Access Compliance Report

Public Rights-of-Way

(Curb Ramps)

Intersection ID: 18844	Main Street: NATIONS_FORD_RD	Cross Street: TYVOLA_RD	Location: NE
ADA ID: 499DA1765330	Ramp Type: IslandPerp	Initial Pass/Fail: Fail	Overall Compliance: No
Severity Score: 22.5			
Codes/Mitigation Info/Possible Solution		Field Measurements/Component Compliance

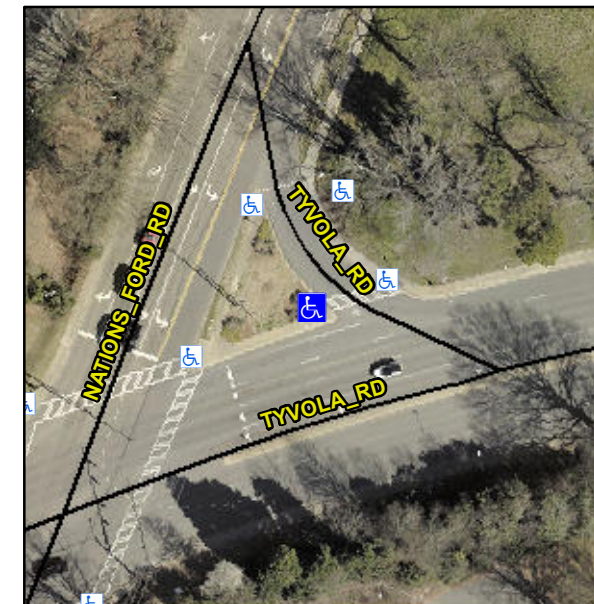
Not Found, R304.5.1, R304.2.2, R304.5.3

Compliance	Description	Data	Compliance	Description	Data
N/A	Ramp Length (in)	60.0	No	Ramp Slope (%)	9.0
No	Ramp Width (in)	39.0	No	Ramp XSlope (%)	2.8
N/A	Flare Type LT	N/A	N/A	Flare Type RT	N/A
N/A	Flare Slope LT (%)	N/A	N/A	Flare Slope RT (%)	N/A
N/A	Flare Traversable LT?	N/A	N/A	Flare Traversable RT?	N/A
N/A	Landing Length (in)	N/A	N/A	DWS Provided?	N/A
N/A	Landing Width (in)	N/A	N/A	DWS Contrast?	N/A
N/A	Landing Slope (%)	N/A	N/A	DWS Length (in)	N/A
N/A	Landing X Slope (%)	N/A	N/A	DWS Full Width?	N/A
N/A	Landing Curb? (Y/N)	N/A	N/A	DWS Offset (in)	N/A
N/A	Shared Landing?	N/A			
N/A	Gutter Ponding?	N/A	N/A	Gutter Slope (%)	N/A
N/A	Gutter Lip Ht (in)	N/A	N/A	Gutter X Slope (%)	N/A
N/A	Painted X Walk1?	Yes	N/A	Painted X Walk2?	N/A
	X Walk 1 Direction	To E		X Walk 2 Direction	N/A
N/A	X Walk 1 Width (in)	72.0	N/A	X Walk 2 Width (in)	N/A
	X Walk 1 Slope (%)	1.2		X Walk 2 Slope (%)	N/A
	X Walk 1 X Slope (%)	3.1		X Walk 2 X Slope (%)	N/A

Remove & Replace Entire Ramp.
